Disability Access Audit

Glinton
Nr Peterborough
Cambridgeshire

Sandie Burns
DIAL Peterborough
Kingfisher Centre
The Cresset
Bretton
Peterborough
PE3 8DX

15th August 2013

Stairs, Tactile Warning & Key Dimensions

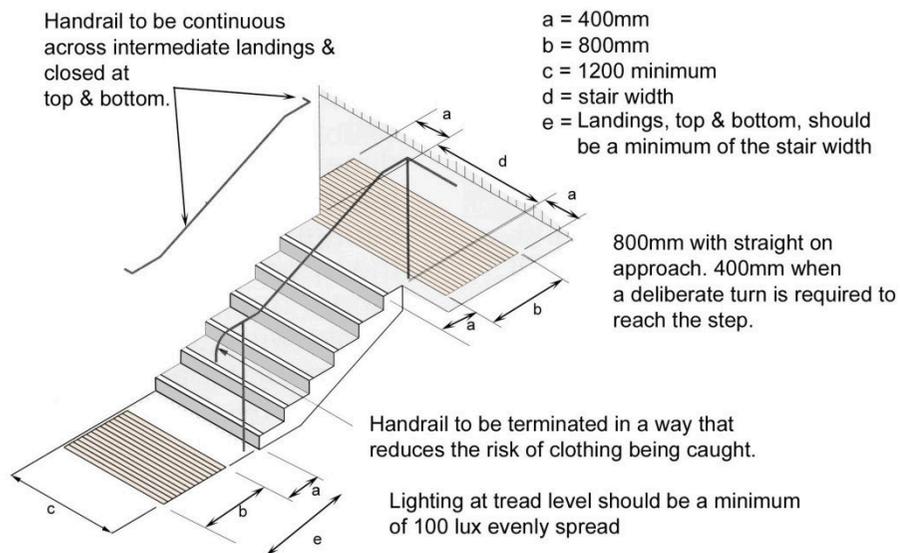
7.9	The route is level (i.e. with no gradient steeper than 1 in 20 and with no steps) for the most part, see 7.10 steps.		
7.10	Starting on the opposite side of the road to Ashburn Close there seven short rise flight of steps down from the highway to the footway. These typically have uniform height risers (200mm) and treads (300mm) of equal depth. The steps are steep with a handrail to one side only (left when climbing) at a typical height of 600mm and 1070mm, these are of a similar design to key clamp. Handrails should be provided to each side of a flight of steps. The width of the steps is typically 900mm. The following has not been provided: tactile warning, colour contrasting nosings, suitable sized landing to the top, handrails which extend horizontally beyond the top and bottom of the flight. To provide tactile warning and suitably sized landings to the top is not seen as feasible/reasonable.	Provide contrasting nosings, provide handrails to both sides of the steps or at the very least alternate handrails to the left and right sides of the steps

Ref	Observation	Recommendation	Priority
7.11	Steps to path opposite Ashburn Close: There is no alternative ramped access route between the steps, people who cannot negotiate the steps have to use the footway starting at either end which is approximately 90m. Consideration should be given to installing a ramp approximately half along the path length, this would also require no parking at the top of it.	Consider the provision of ramped access	
7.12	Drainage gratings are not within the access route.
